PLAN # 23-0017 GL

FOUNDATION/LOWER LEVEL FLOOR PLAN 810 SQ. FT. FINISHED AS SHOWN SCALE: 1/4"=1'-0"

**STAIR SECTION** SCALE: 1/4"=1'-0"

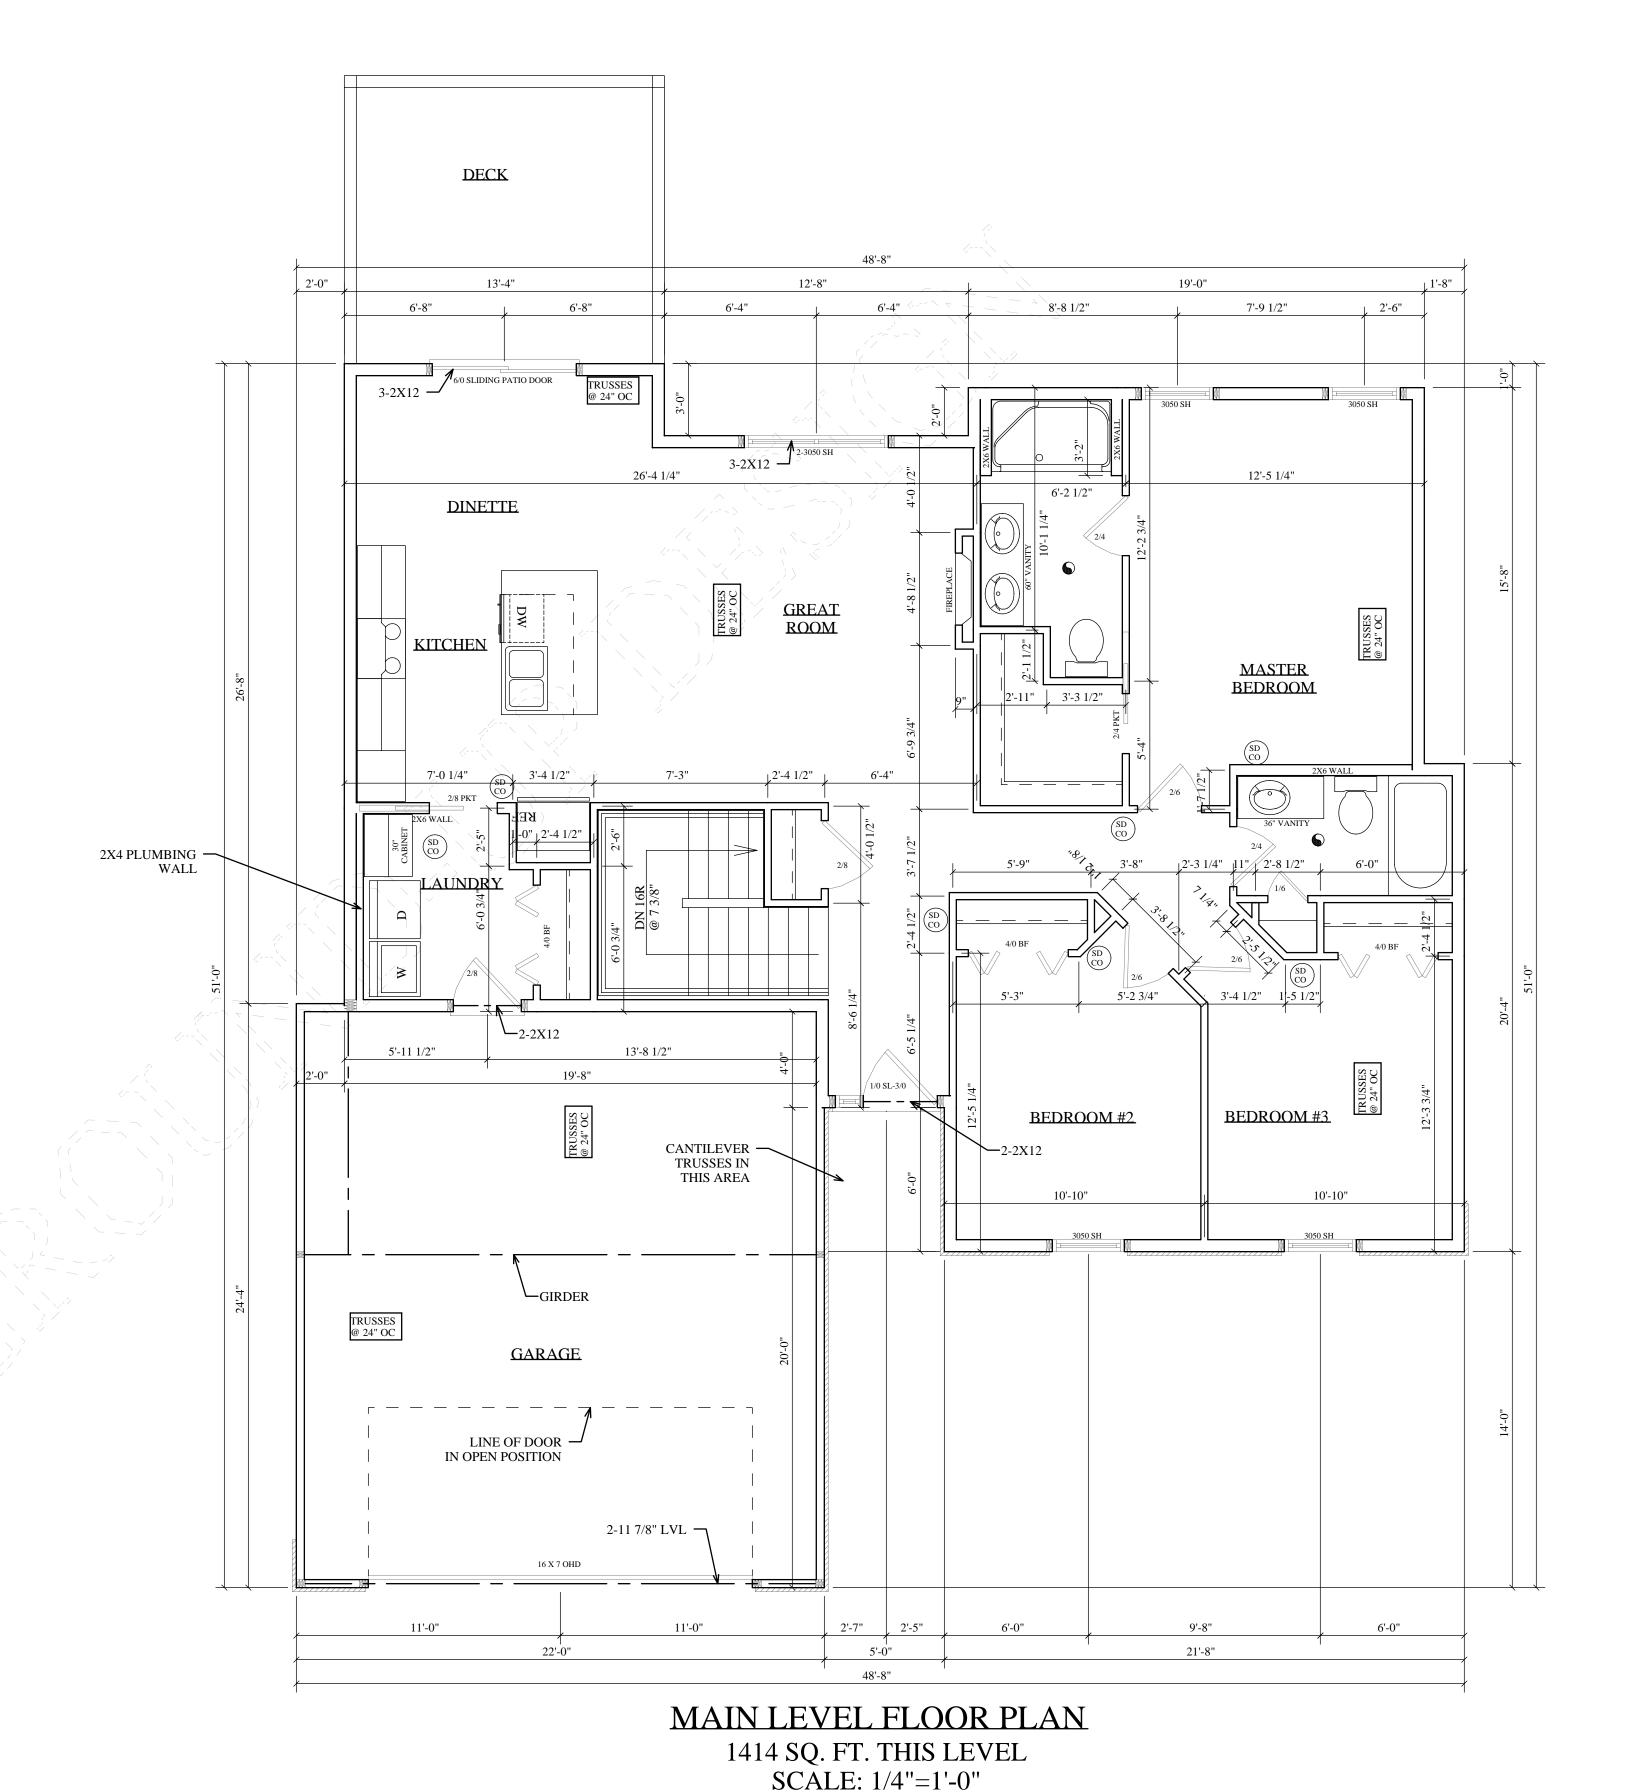
1. Smoke detectors required to be identified in each bedroom, hallways leading to bedrooms and at least one on each floor level. 2. Carbon monoxide detectors required to be identified outside each sleeping area in the immediate vicinity of the bedrooms. 3. Radon control method required to be identified either with a drawn detail or a plan note.
4. Stairs need to be detailed to show riser height will not exceed 7 ¾ inches and minimum tread width of 10". Also, stairs with more than 30 rise need solid risers or openings such that a four inch (4") sphere will not pass through.

5. House to garage separation will be provided with a minimum ½ inch gypsum board on walls and ceilings unless there is habitable room above the garage then the ceiling will have minimum 5/8 inch type X gypsum board. 6. Windows required to have safety glazing will need to be identified on the plans.

a. Glazing in tub enclosures and within 5 feet of tubs, showers, whirlpools, hot-tubs, and pools if also within 60" of the walking surface. b. Within 24" of a door edge when in the closed position if also within 60" of a walking surface c. Within 5' of the top or bottom of stairs if also within 60" of a walking surface d. Within 18" of the floor if also greater than 5 square feet in area.

7. An attic access opening of minimum 20" x 30" is required in a corridor, hallway or other readily accessible location. It shall not be located in a closet, bathroom, mechanical room, laundry room or similar room or locations. 8. Eight visit-ability requirements required to be shown on the plans: a. Interior doors: At least one bedroom, one bathroom and all other passage doorway header widths, on the level served by the designed step-less entrance, must be framed to accommodate a minimum 38" clear rough opening. The framing for the doorway width opening may be reduced to accommodate any door size provided pub open ninety degrees (90), measured between the face of the door and the opposite stop. Note: A 34" door hung in the standard manner, provides an acceptable 32" opening. Exception: Doors serving closets twenty-four inches (24") or less in depth. Plans shall show that all doors required to meet this regulation are allowed enough space to meet this requirement and identified with a note stating Minimum Framed Opening Width 38 - Actual Door Size insert door size. b. All wall switches, controlling light fixtures, fans, all temperature control devices and all receptacles shall be located in an area between fifteen (15) and forty-eight (48) inches above finished floor.

c. Electrical panels shall be located so that the individual circuit breakers are located between 15" and 54" above the floor. d. Sanitation facilities: There must be at least one bathroom containing a water closet (toilet), lavatory (sink) and a shower, bathtub, or combination bath/tub located on the level of the dwelling to be accessed by a step-less entrance. The room must be designed in a manner that will provide a minimum of thirty inches (30") by forty-eight inches (48") clear floor space at the water closet and lavatory. The clear floor space shall not be obstructed by a doorway swing; however, clear floor space at fixtures may overlap if sufficient maneuvering space is provided within the room for a person using a wheelchair or other mobility aid to enter and close the door, use the fixtures, reopen the door and exit. Doors may swing into the clear floor space provided at any fixture if the maneuvering space is provided. Maneuvering space may include any knee space or toe space available below bathroom fixtures. If public funds are not used and a proposed bathroom design shows a shower, bathtub or combination tub/shower can be provided within the room or an adjoining room than the shower or bathtub is not required. e. Wall Reinforcement: A bathroom must be provided with wood blocking installed within wall framing to support grab bars as needed. The wood blocking, when measured to the center, will be located between thirty-three inches (33") and thirty-six inches (36") above the finished floor. The wood blocking must be located in all walls adjacent to and behind a toilet, shower, or bathtub. f. Step-less Entrance: At least one building entrance must be designed, without encroaching into any required parking space, that complies with the Iowa City Building Code standard for an accessible entrance on an accessible route served by a ramp in accordance with section R311.8 or a no-step entrance. The accessible route must extend from a vehicular drop-off, or parking to a building entrance. The entry door must have a minimum net clear opening of thirty-two inches (32"). Note: Iowa City code only requires one parking space for single family dwellings g. Garages: Must be wired for power operated overhead doors. h. All exterior decks and patios surfaces adjacent to the level served by the designed step-less entrance must be built within four inches (4") of the dwellings finish floor level or top of threshold whichever is higher for at least fifty percent (50%) of the deck or patio area. 9. Egress windows need to be identified. 10. Deck footings are required to be properly sized. NOTES: \* 2X6-9' 1 1/8" WALLS WITH 1/2" SHEATHING. \* EXTERIOR DIMENSIONS ARE TO OUTSIDE OF SHEATHING. INTERIOR DIMENSIONS ARE TO CENTER OF WALL AND/OR BEAM. \* ALL HEADERS AT EXTERIOR OPENINGS ARE 3-2X12 WITH 1/2" FILLER UNLESS NOTED OTHERWISE.
